EG&G ENERGY MEASUREMENTS GROUP

Subject: INSPECTION STATUS REPORT
Reference: Memo; D. Kirsh to W. Wade dated 30 November 1983

SUMMARY of DIABLO CANYON INSPECTION * of '82 MODIFICATIONS FROM ^{the}INDEPENDENT DESIGN VERIFICATION PROGRAM

NONCONFORMANCE REPORT

DETAIL S-190

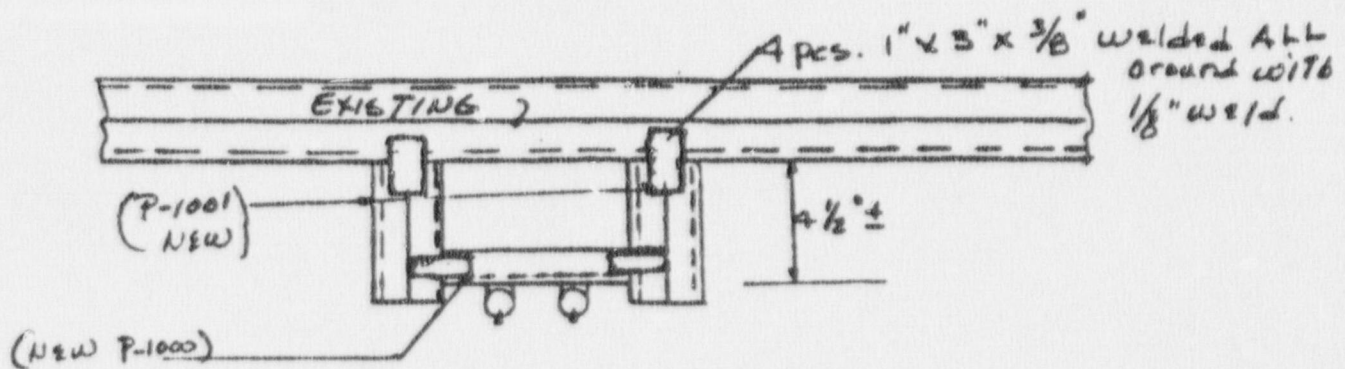
Problem On detail S-190 (CSR-127-4-52) the recommended "fix" can not be done. Do you have an alternate method?

1. We cannot modify support per detail S-190 as
 supplied by Engineering. Above sketch is suggested.
 Do you concur?

PACIFIC GAS & ELECTRIC CO.	
APPROVED FOR CONSTRUCTION	
ENGINEERING DEPARTMENT	
BY ED EPSTEIN	DATE 1/21/53

FOR Support No. CSR-127-6-343 Detail S-428

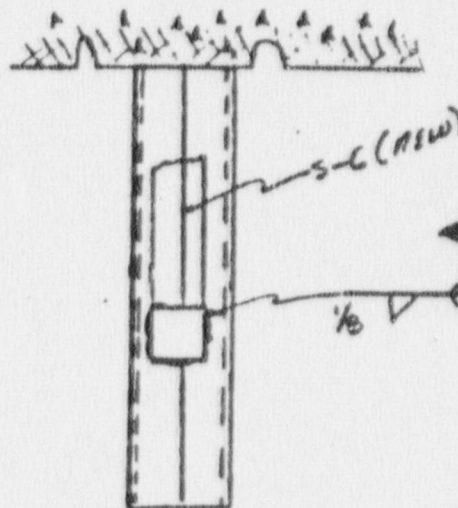
On detail S-428 (CSR-127-6-343) the weld symbol shows we have to weld all the way around. Can we weld on three sides only?

(Proposed) ① Because of space limitation we can only weld 3 sides (bottom & 2 sides). Is this good enough?

1. Welding 3 sides of the S-L brace is good enough. PER ~~ED~~ EPSTEIN (OPEG)
